Project Name: Lemoyne Relief Sewer

Project Number: 21-1

Location: Village of Oak Park , Illinois  
Lemoyne Parkway – East Avenue to Edmer Avenue

2 OF 25

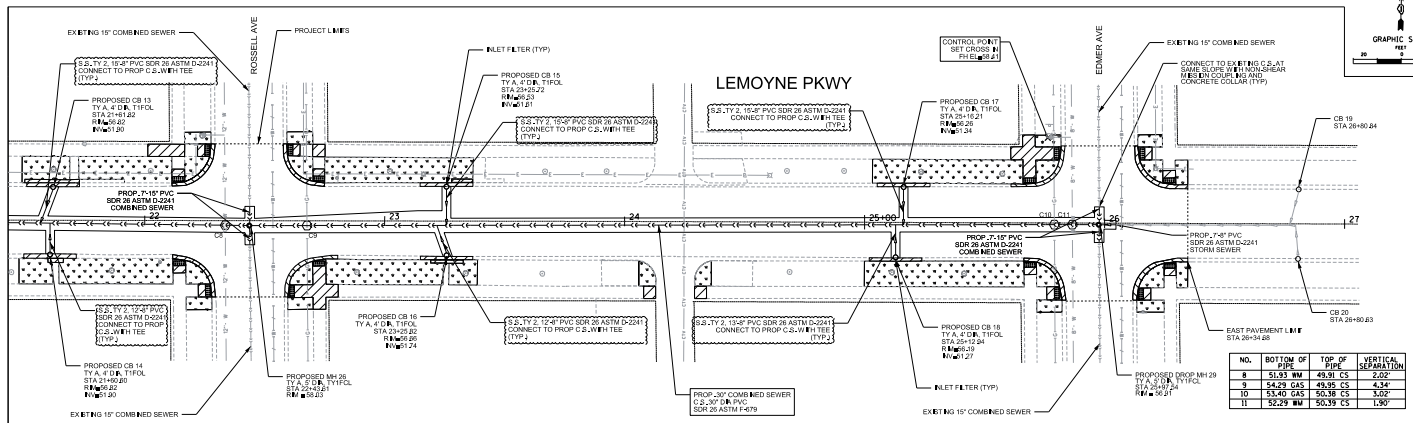
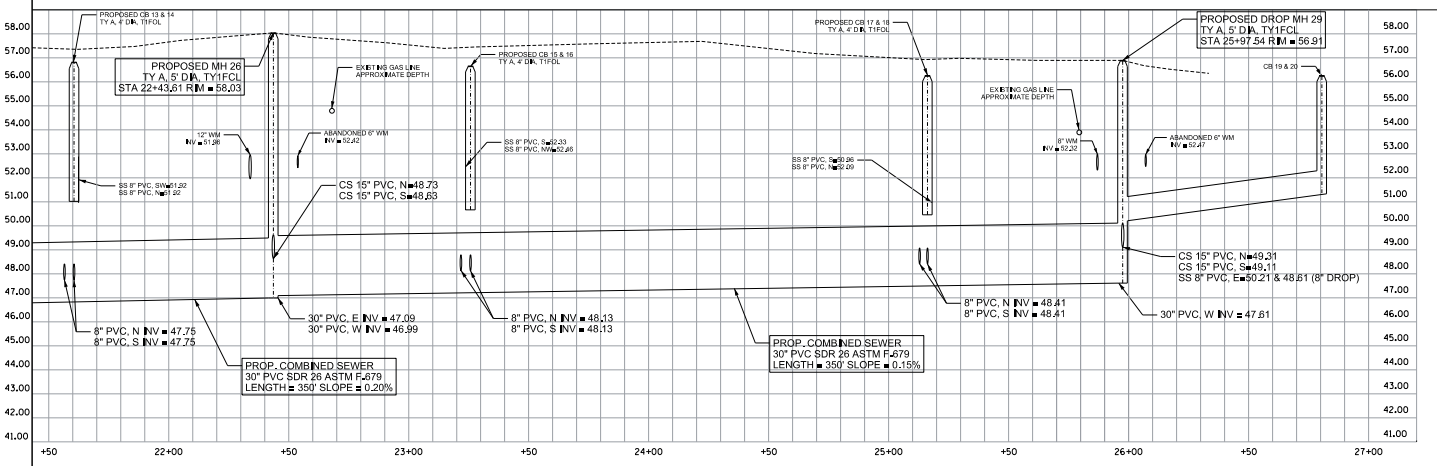
- 4. *Comment: The pipe length totals on the sewer summary table are inconsistent with the pipe lengths provided on the utility plan. Please revise.***  
***Response: The pipe lengths shown on Schedule B have been updated to match the plans. Sheet 2 (Summary of Quantities) of the plans has also been updated.***
- 5. *Comment: Provide the lengths of the 8" proposed storm sewers that connect with CB 3 – 18.***  
***Response: Lengths have been provided for the proposed 8" storm sewers that connect with CB 3 – 18 on sheets 9-11 of the plans.***
